Specifications for the **LT<sup>®</sup>1020** have changed as shown below in **bold**. For complete specifications, typical performance characteristics and applications information, please see the **LT1020** data sheet.

## PACKAGE/ORDER INFORMATION

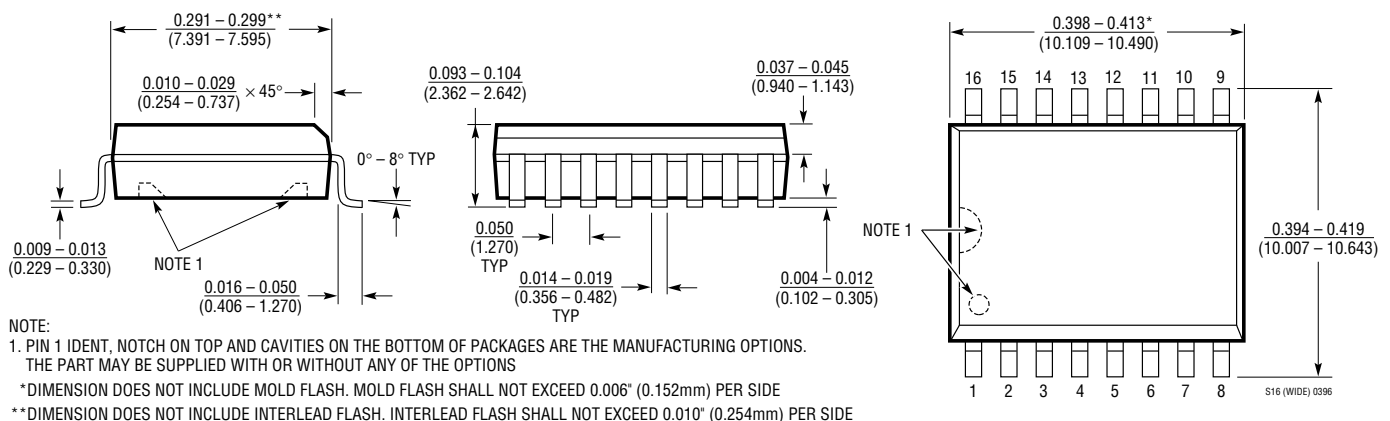
Pins 12 and 13 of the LT1020's surface mount package were reversed under the Package/Order section. Please note the correct pin description. Also, the data sheet incorrectly shows the LT1020's 16-pin surface mount package as a 0.150" narrow body. The LT1020 has always been offered in a 0.300" wide body 16-pin SO. The suffix "W" has been added to the LT1020CS/LT1020IS to indicate that the LT1020's surface mount package is a wide 16-pin SO.
